Independent Technical Advice: Northern Link Road Tunnel Project Change

December 2010

**Department of Infrastructure and
Planning**

Parsons Brinckerhoff (PB) has been engaged by Significant Projects Coordination of the Department of Infrastructure and Planning (DIP) to undertake an independent technical review of the key aspects associated with the proposed changes to the Reference Design (RD) for the Northern Link Road Tunnel (NLRT) Project.

Figure 2-2: Changed Project Horizontal Alignment

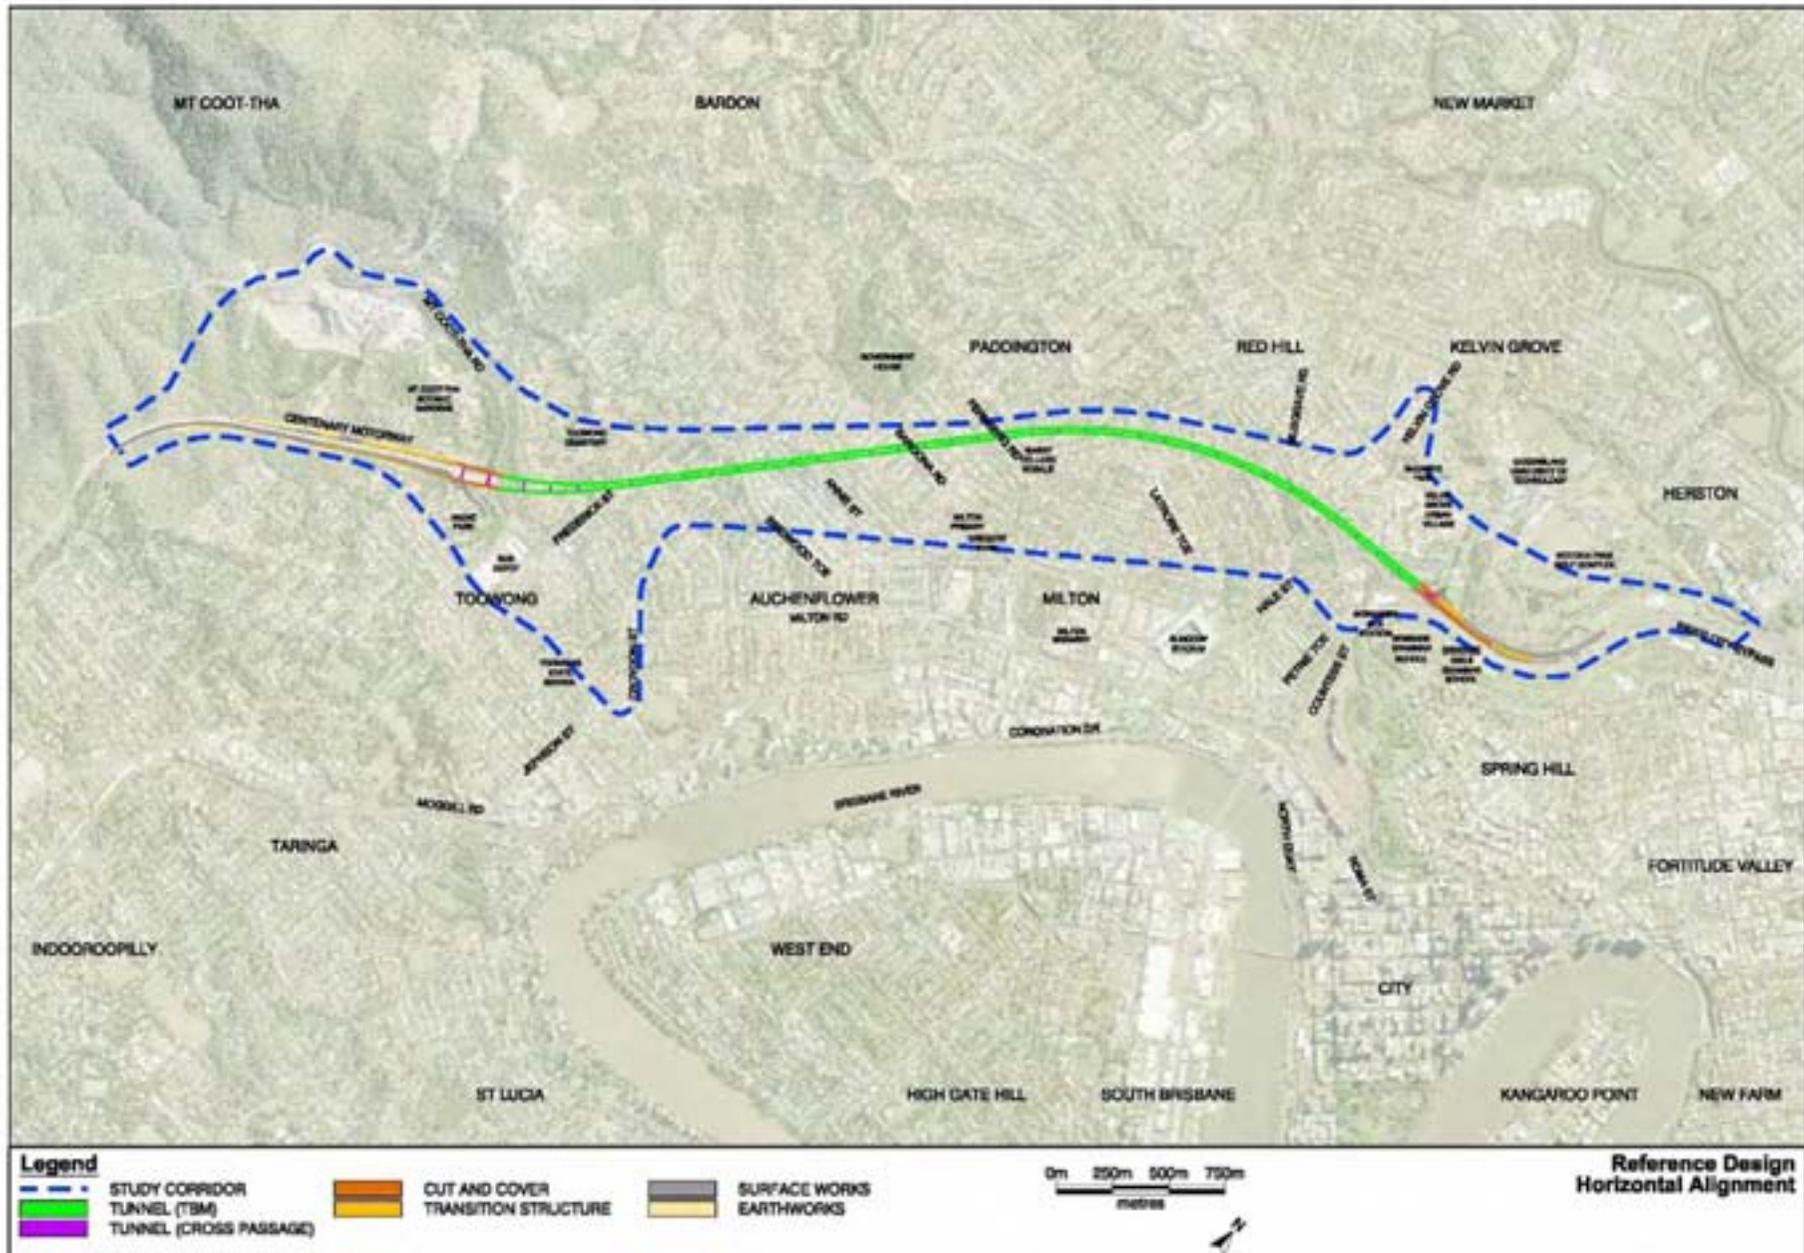
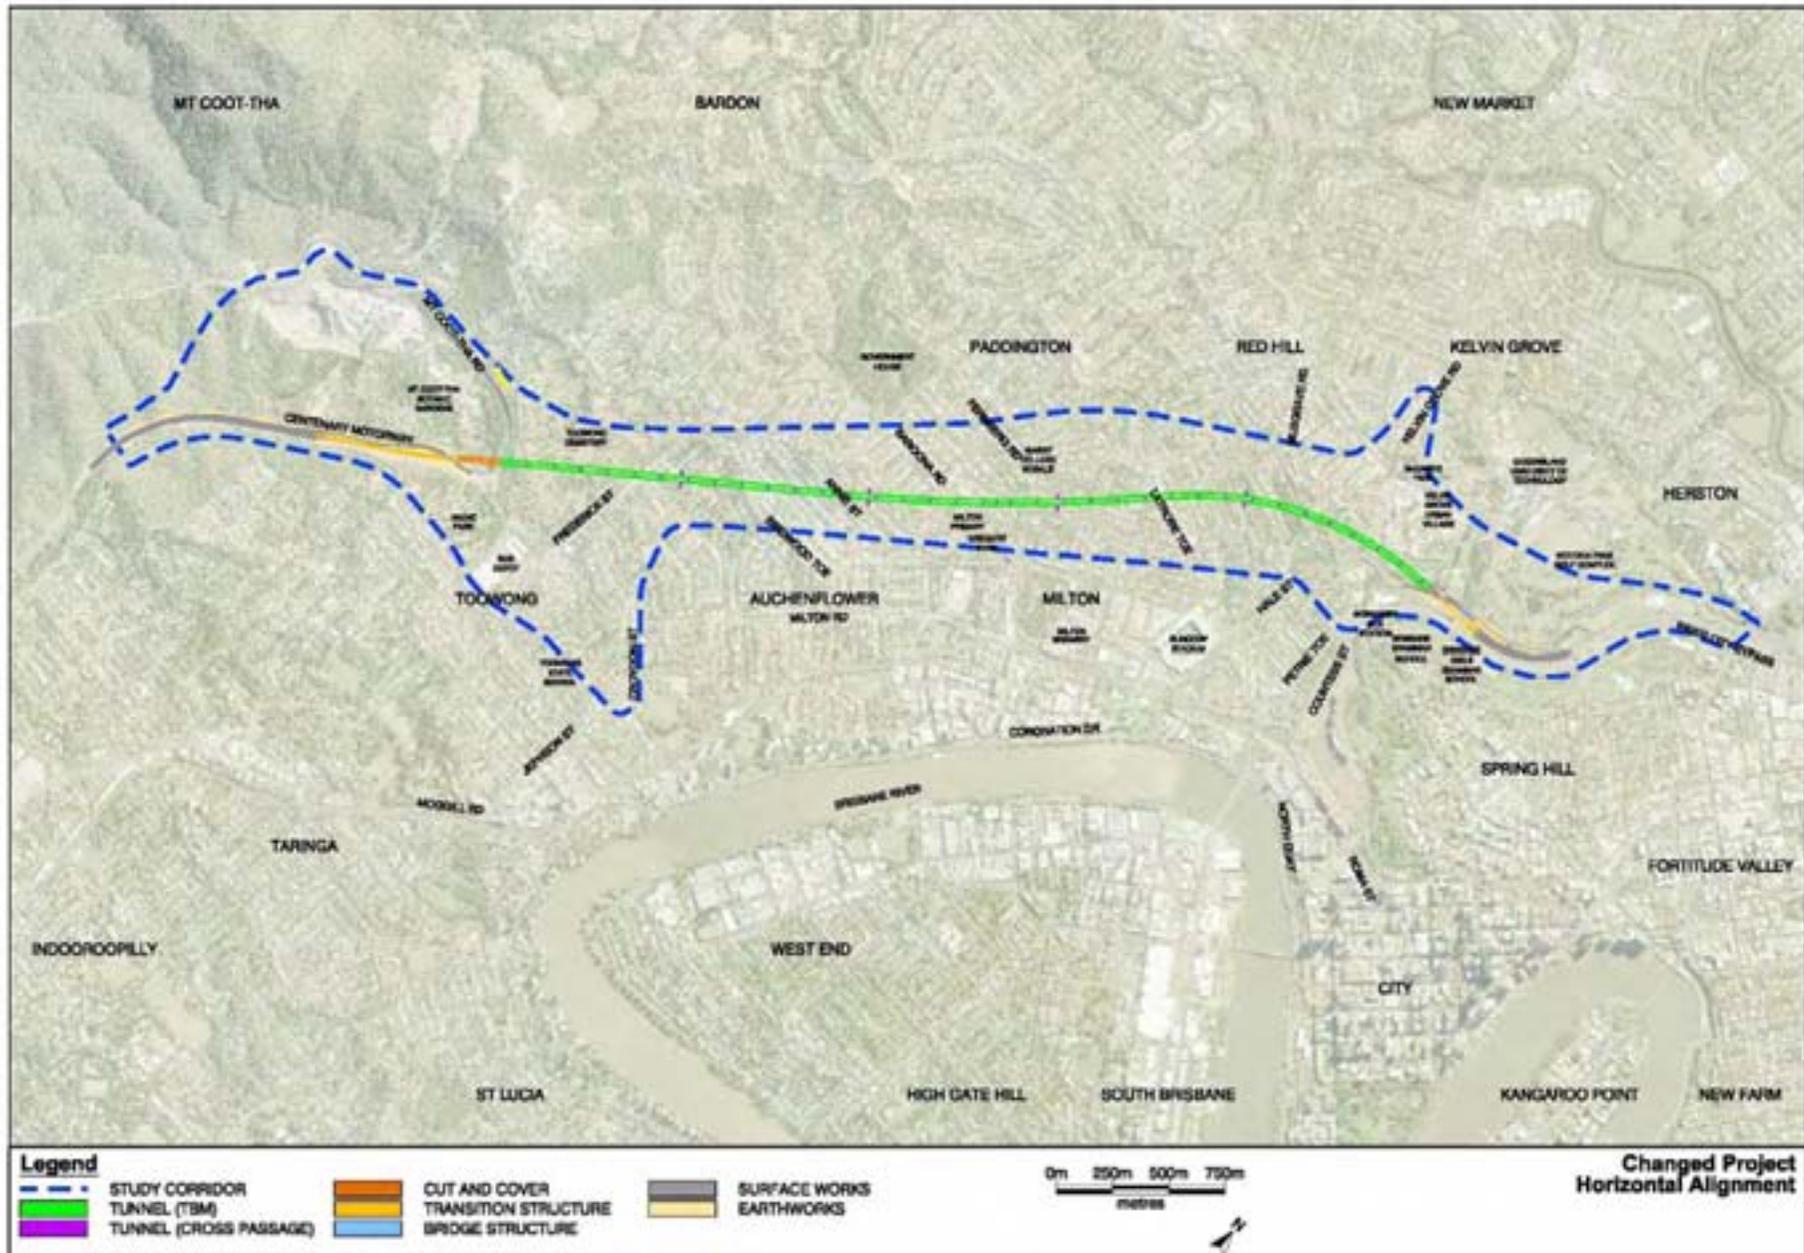
The modification to the horizontal alignment will impact the volumetric title requirements. Given the nature of the surface terrain, it will also change the depth of overburden above the tunnel. The change in vertical alignment will generally reduce the overburden (depth of burial) of the tunnel. On the RD alignment there are no locations other than close to the portals where the tunnel main drive lies within one diameter (1D) of the ground surface. There are three such locations on the changed alignment (refer Figure 2.4 of the Project Change Report). These represent a significant challenge to the proponent.

The principal change to the Reference Design is the proposed realignment of the main tunnels between the connections with the Centenary Motorway and the ICB. The main tunnel alignments would be straighter and shallower to create a more direct, safer and more efficient motorway-standard link between the Centenary Motorway and the ICB. These changed alignments are shown in **Figure 2-1** and **Figure 2-2**.

Figure 2-4: Changed Project Vertical Alignment

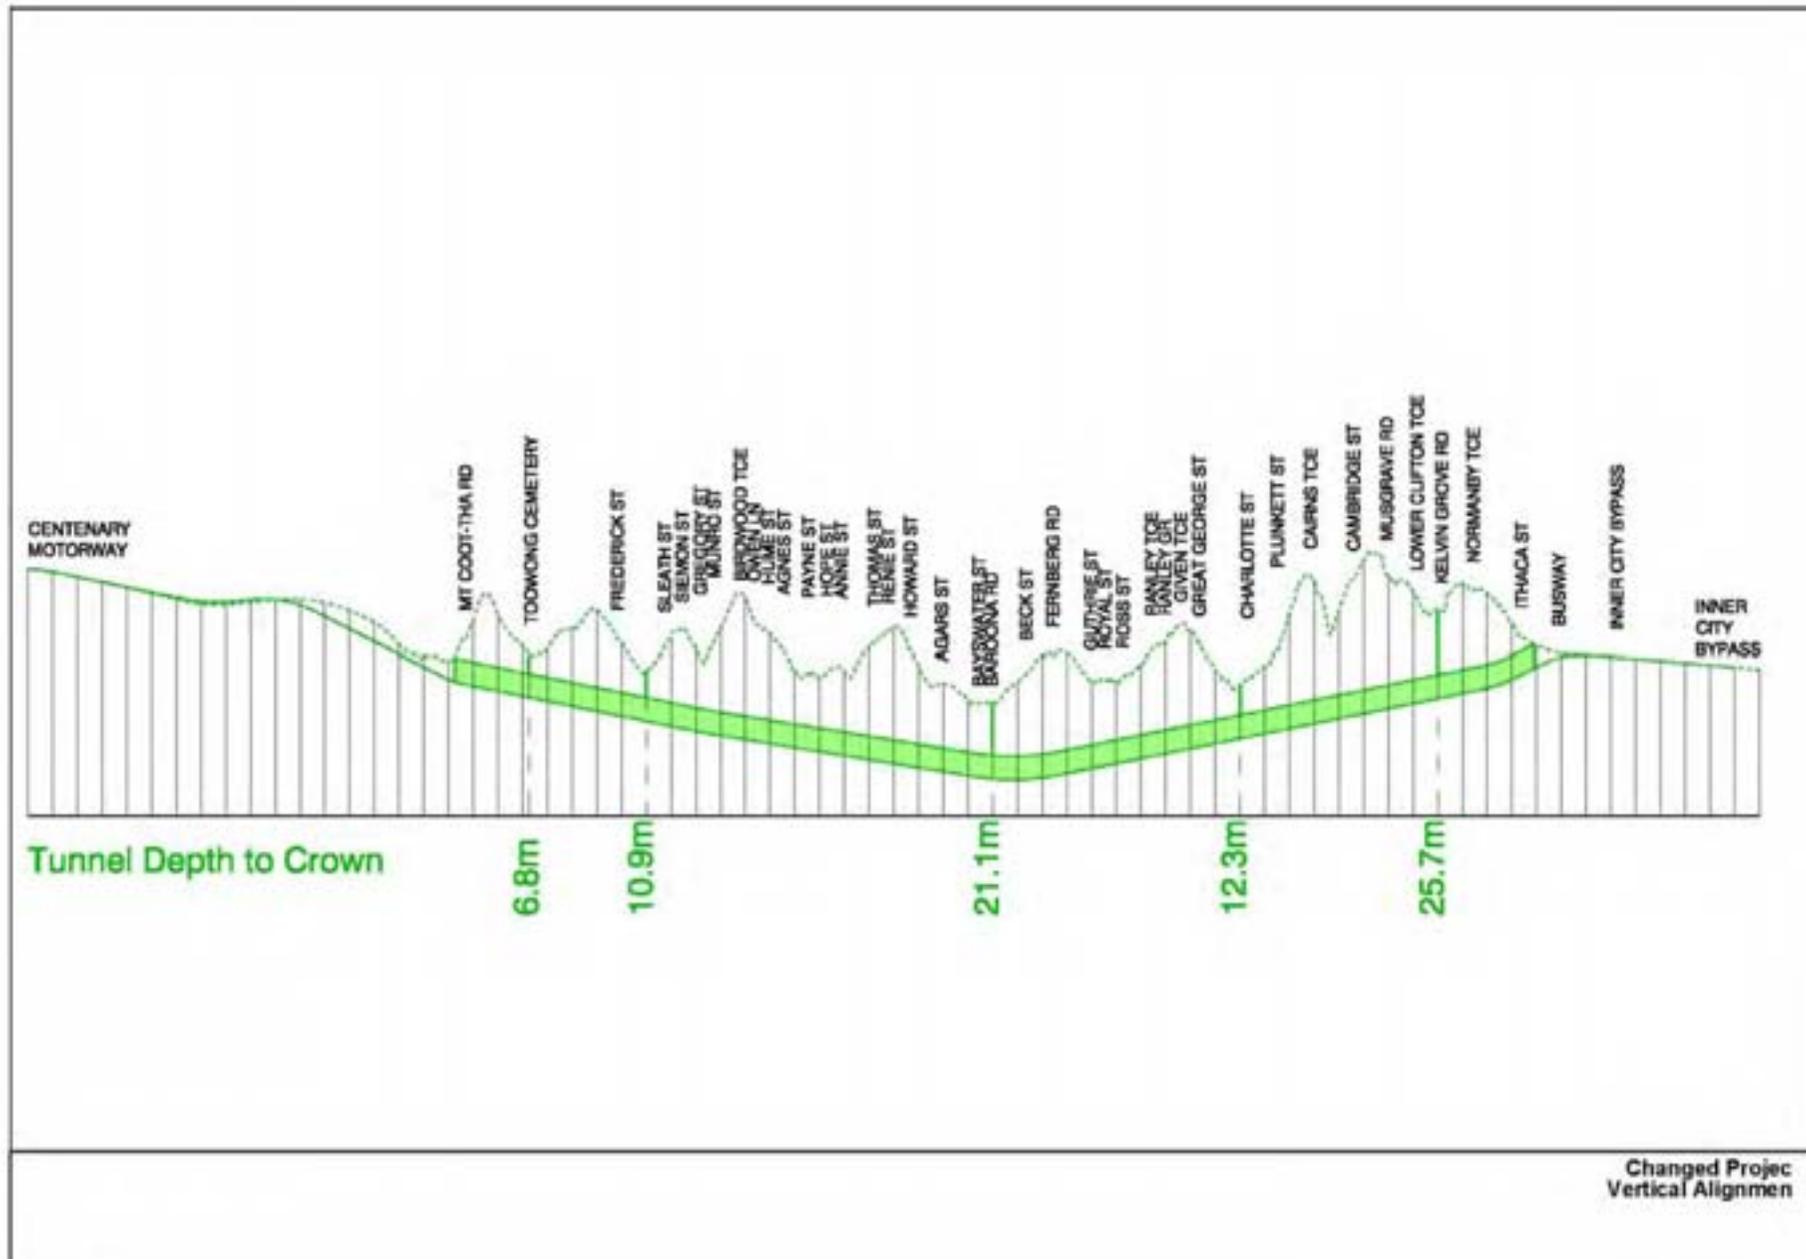
Table 2.3 of the Project Change Report tabulates approximate depths of cover to the tunnel crown, but the figures do not fully reflect the minimum levels of cover indicated on the long section provided in Figure 2.4 of the report.

- the Contractor's tunnel Construction Management Plan should be required to include specific reference to locations of low overburden and special measures put in place to ensure a heightened level of vigilance when construction activities are being undertaken in these areas. Surveys and ground instrumentation should be required to be in place and a detailed ground monitoring regime installed and fully baselined before tunnelling is allowed to proceed below points where the tunnel excavation is within 1.5D of the ground surface.

- a detailed plan of additional site investigation proposals must be submitted and detailed requirements assessed for areas of high risk including areas of low cover (less than 1.5D) and areas of mined tunnel excavation close to potentially sensitive surface deposits and structures
